ADDENDUM NO. 01

Amendments to RFP/EPC Bidding Document for Engineering, Procurement and Construction (EPC) of Attabad Lake Hydropower Project (54 MW) Package-III: Electro-Mechanical Works

This Addendum No. 01 to RFP/EPC Bidding Document containing the following amendments to the EPC Bidding Document for Engineering, Procurement and Construction (EPC) of Attabad Lake Hydropower Project (54 MW) Package-III: Electro-Mechanical Works is issued pursuant to ITP 8.1 of Volume-I of RFP/EPC Bidding Document.

Drawing No. ALHPP-PPE-0501
 Drawing No. ALHPP-PPE-0502
 Drawing No. ALHPP-SY-0601
 Drawing No. ALHPP-SY-0602
 Drawing No. ALHPP-SY-0603

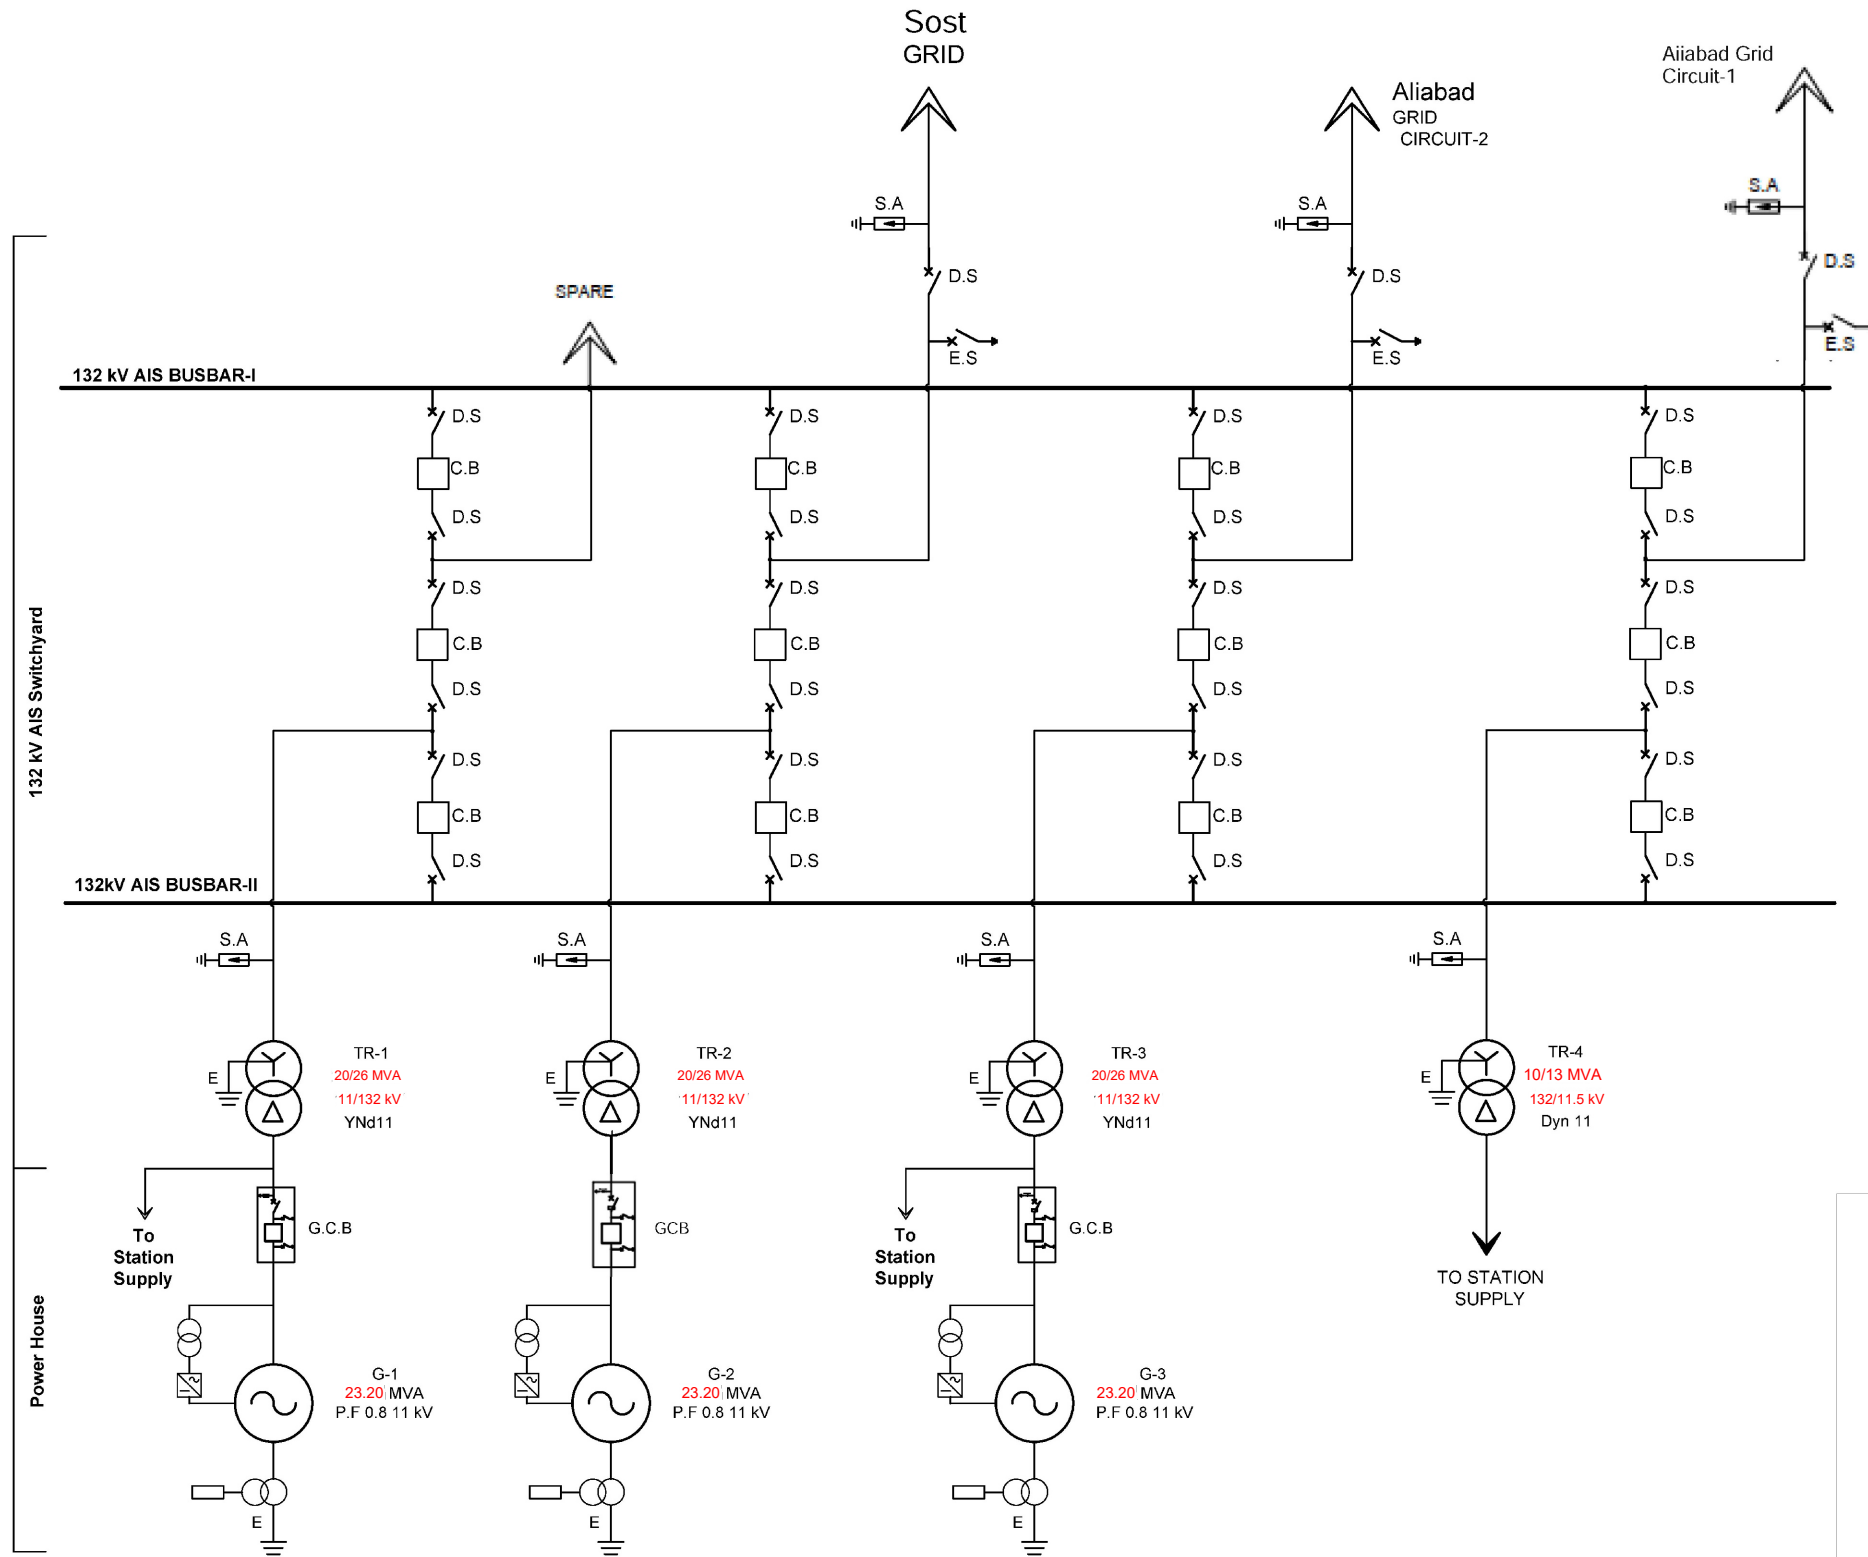
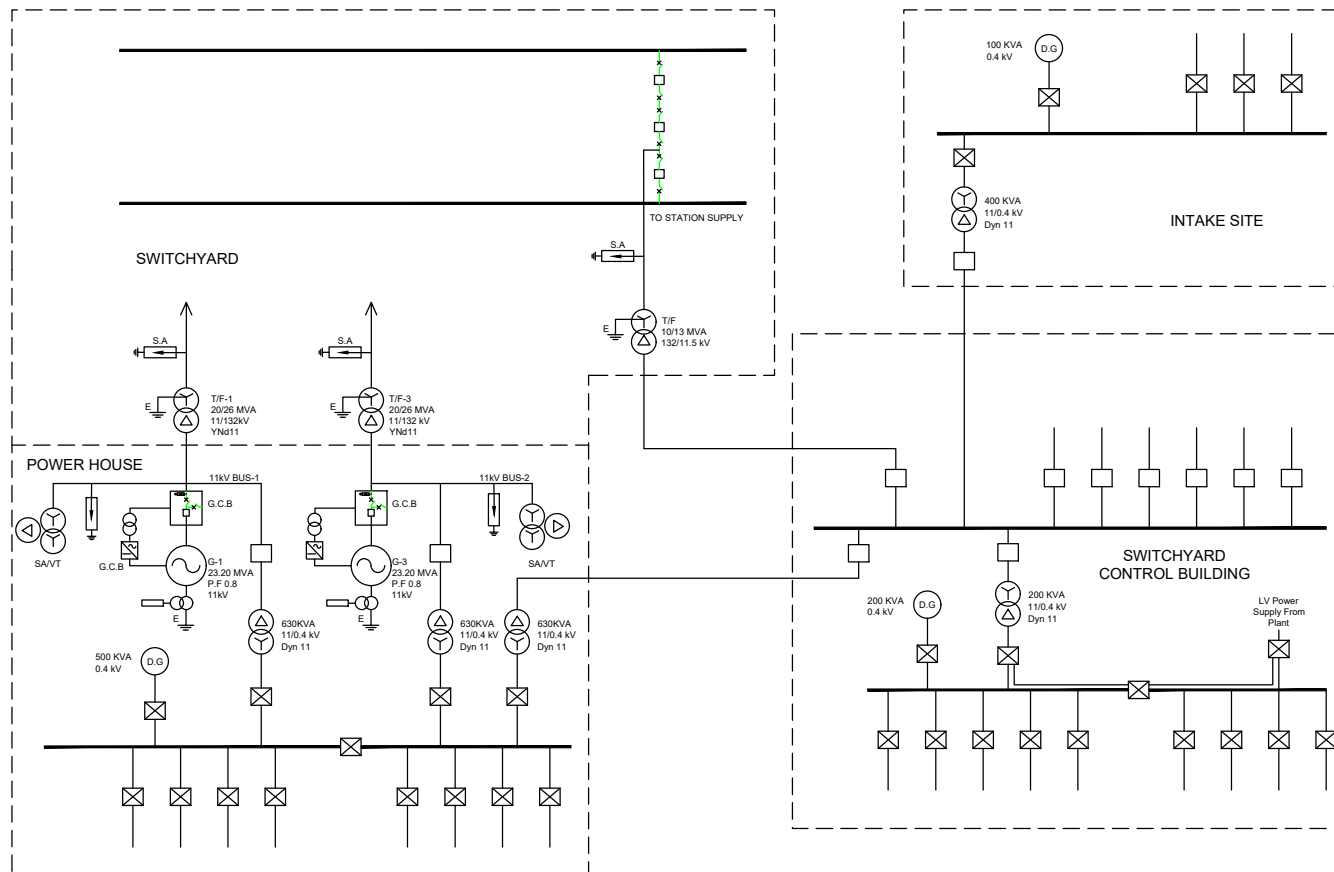
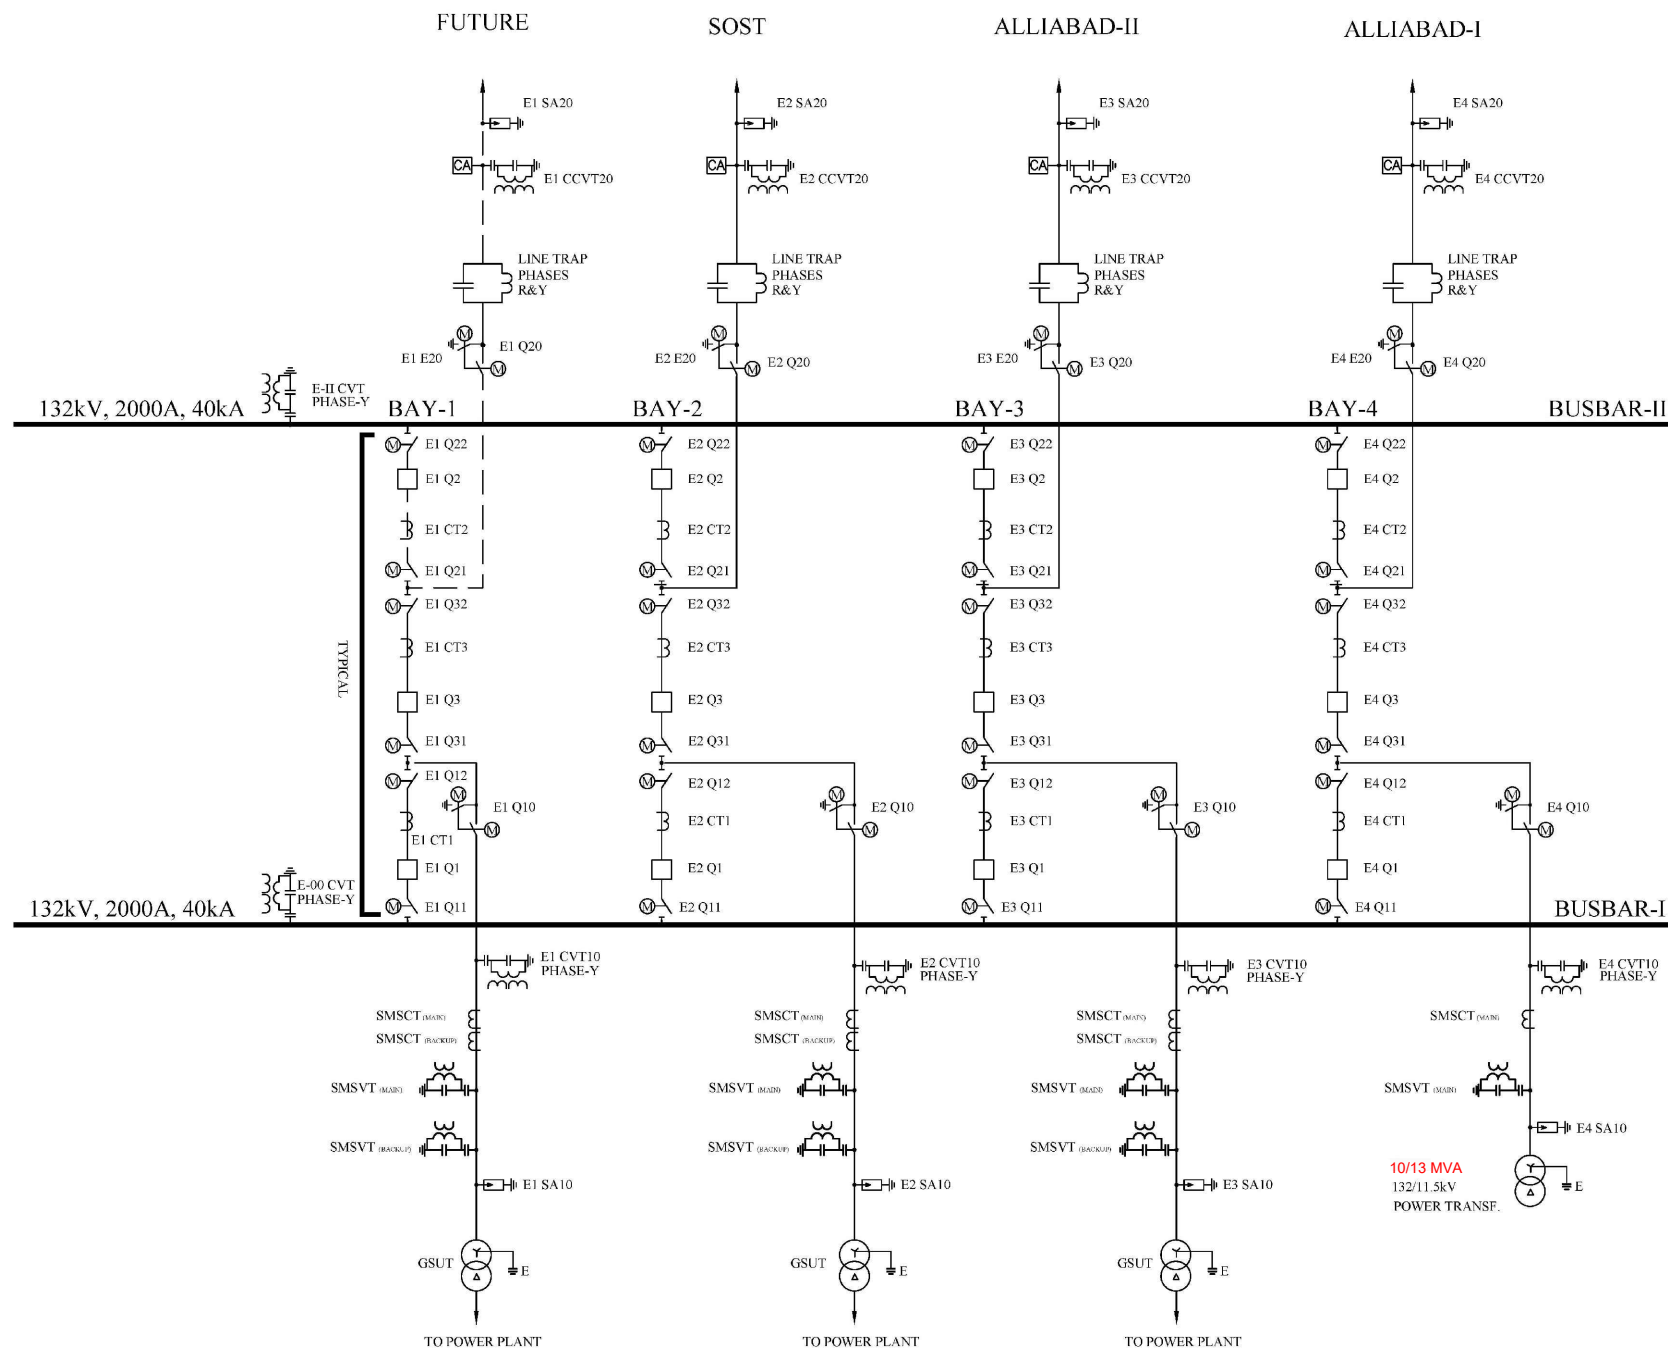
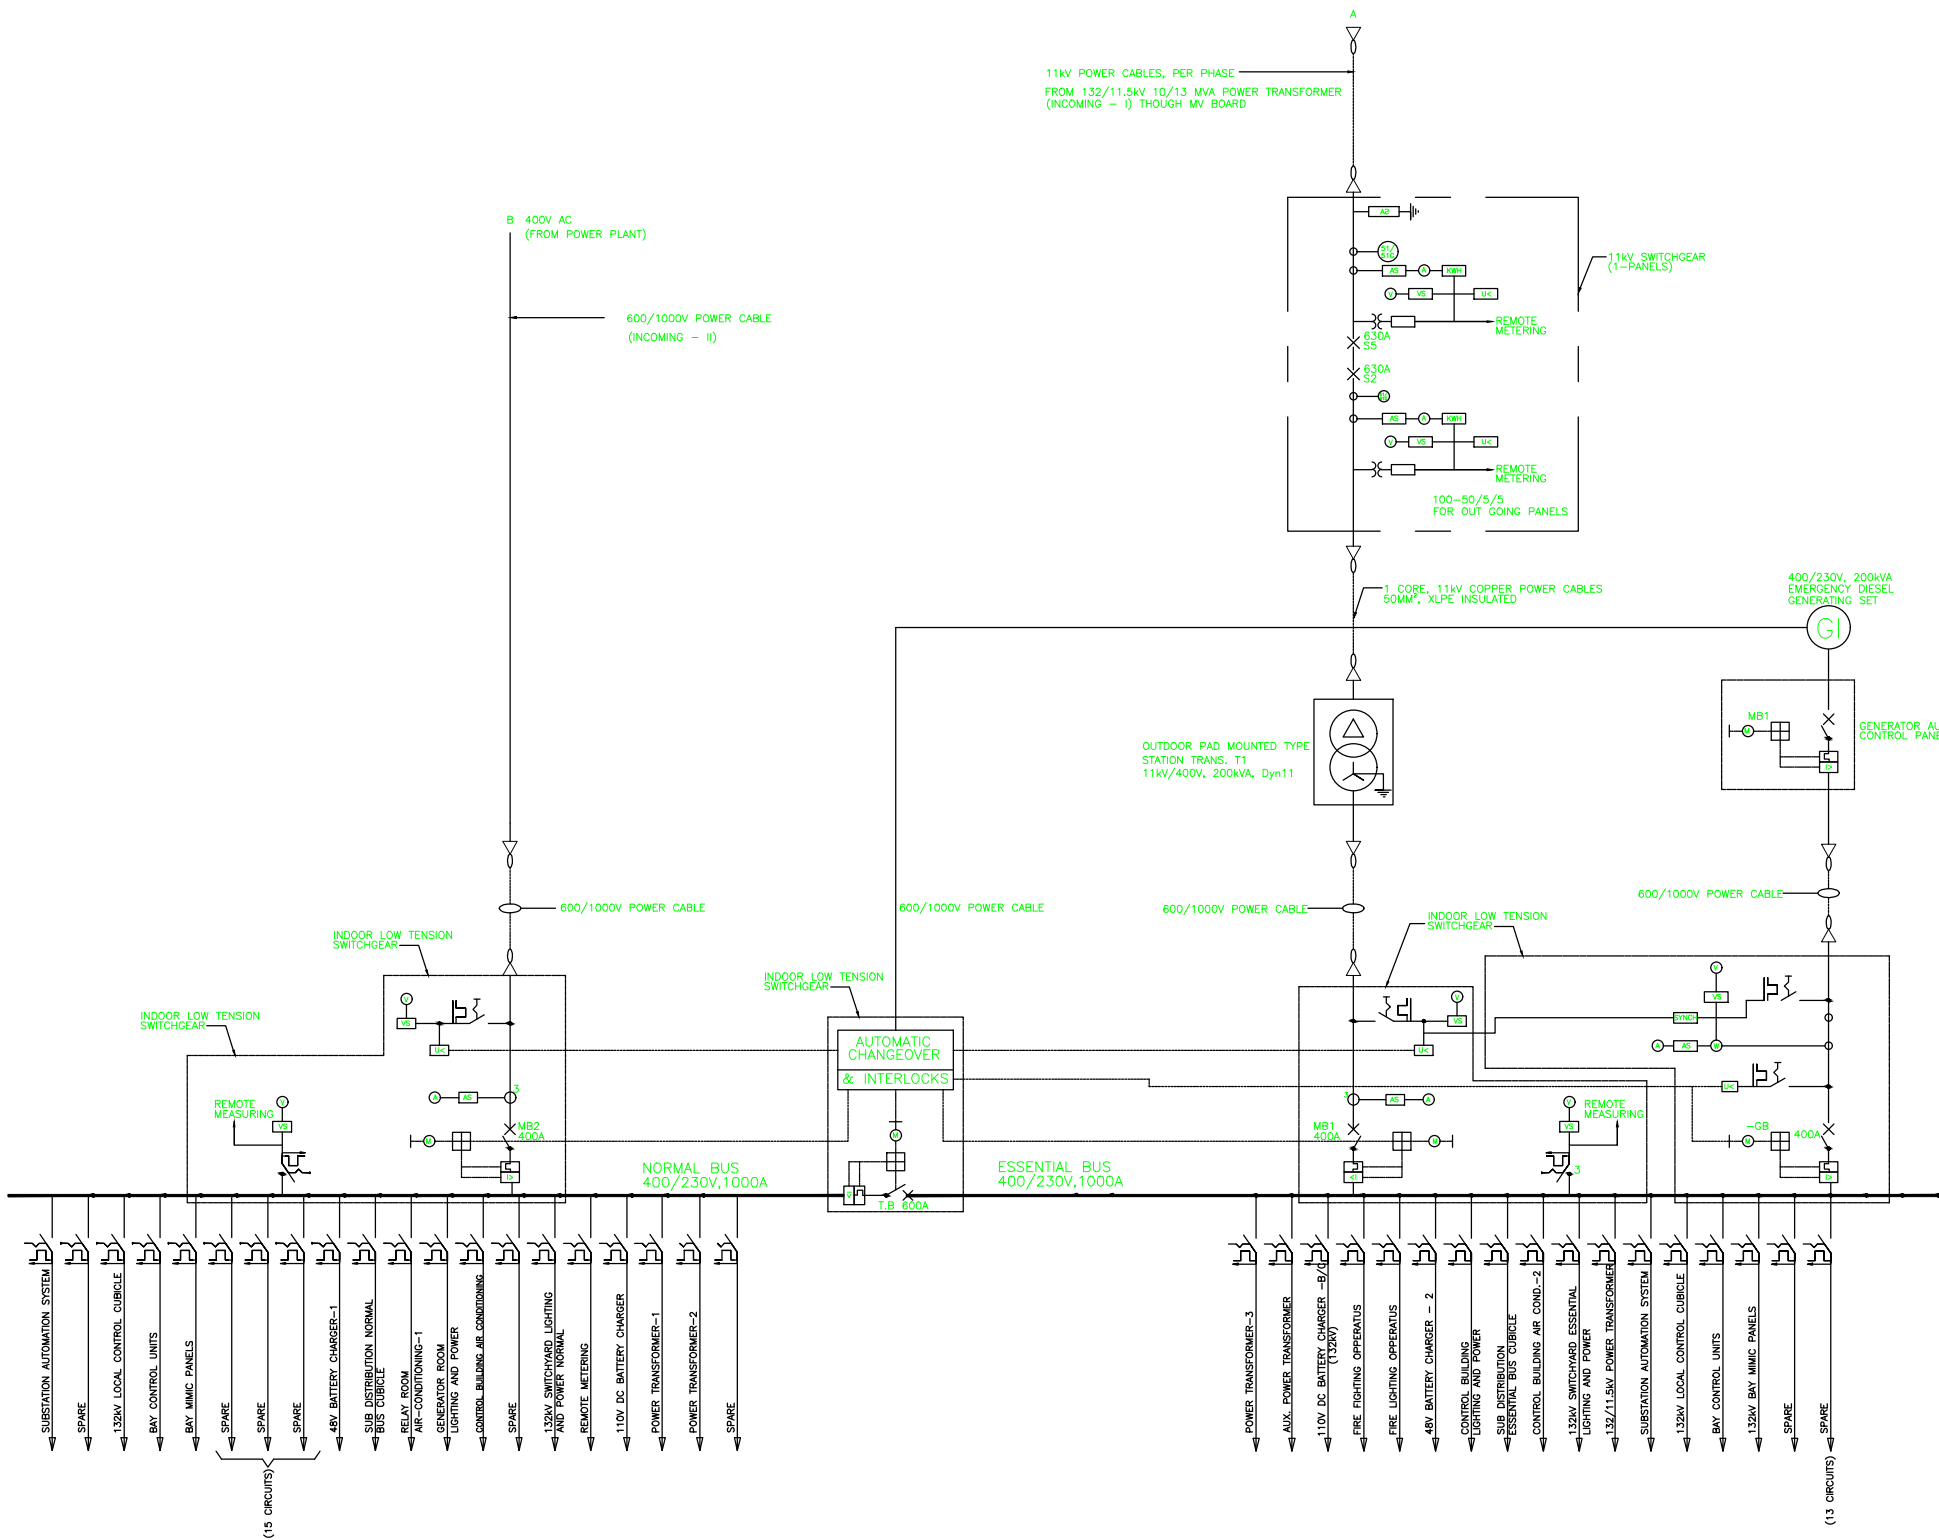
The above-mentioned Conceptual Drawings shall be substituted after deleting in their entirety of 132 kV Remote End Line Bays Conceptual Drawings in accordance with the Original Scope and shall be attached as **Annexure J**.
